From: Mafizul Islam, P.E. <mislam@thesigmagroup.com>
Sent: Monday, April 3, 2023 3:24 PM
To: Martinez, Joseph J - DNR
Cc: Edlebeck, John (J.Edlebeck@wfbvillage.org)
Subject: RE: Whitefish Bay Landfill - Green Tree Prep. Academy Vapor Sampling
Attachments: Green Tree School IAQ & SSV Lab Report - March 30, 2023.pdf; Figure 2 - IA & SSV Sample Locations - March 2023.pdf

**SUB-SLAB VAPOR (SSV) AND INDOOR AIR (IA)
PASSIVE SAMPLE LOCATIONS**
MPS: GREEN TREE PREPARATORY ACADEMY
MARCH 2 THRU 9, 2023
PERFORMED BY THE SIGMA GROUP, INC.

FIGURE 2
GROUND FLOOR PLAN

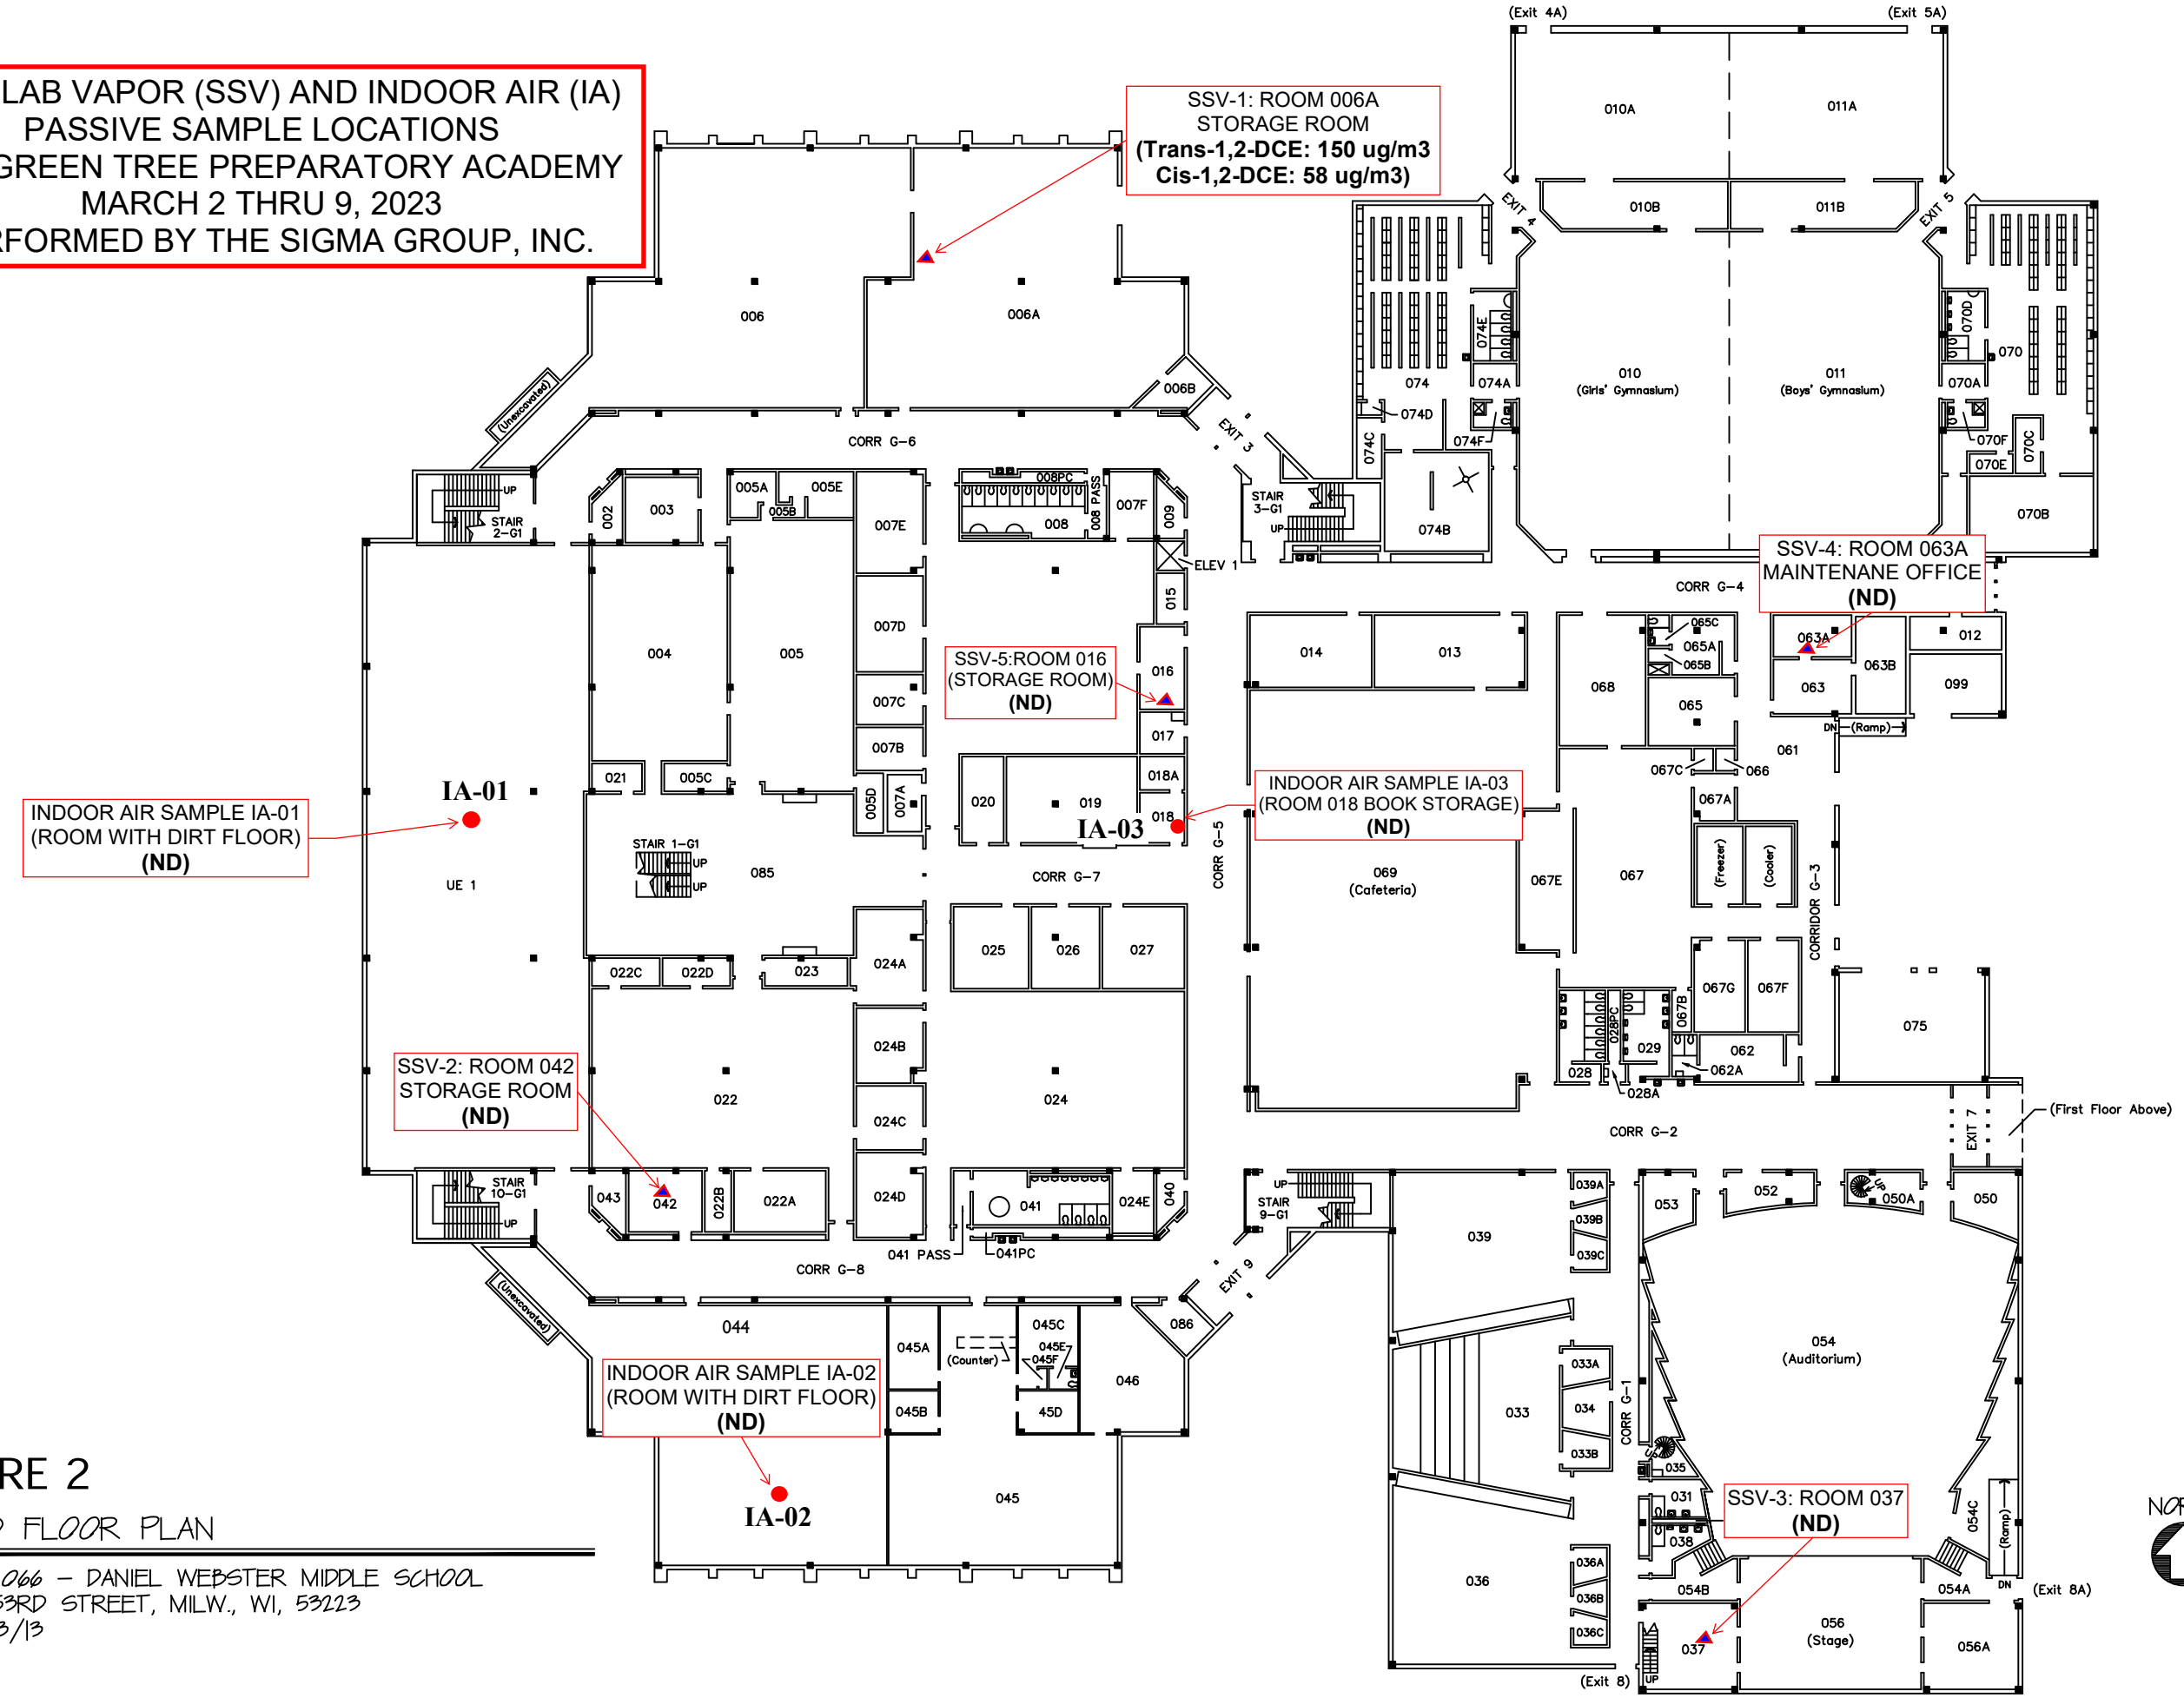
- I understand that conditions in the field restrict where you are able to collect samples, but I recommend additional sub-slab locations near the center of the building and/or near where the groundwater plume is expected to be present beneath the building if possible.

We were able to collect three indoor air samples – two samples from two rooms with bare ground (no concrete) and one from a book storage room near the middle of the building. All three samples were reported non-detect for chlorinated VOCs (see attached lab report).

Also, four of the five sub-slab vapor samples collected from below the building slab were reported non-detect for chlorinated VOCs. The only sub-slab vapor sample detected with two chlorinated compounds (Cis-1,2-Dichloroethene, and Trans-1,2-Dichloroethene) were detected at concentrations significantly below their VRSL value of 1,400 ug/m³.

For your reference attached please find **Figure 2** which depicts the locations of the indoor air samples and sub-slab vapor samples.
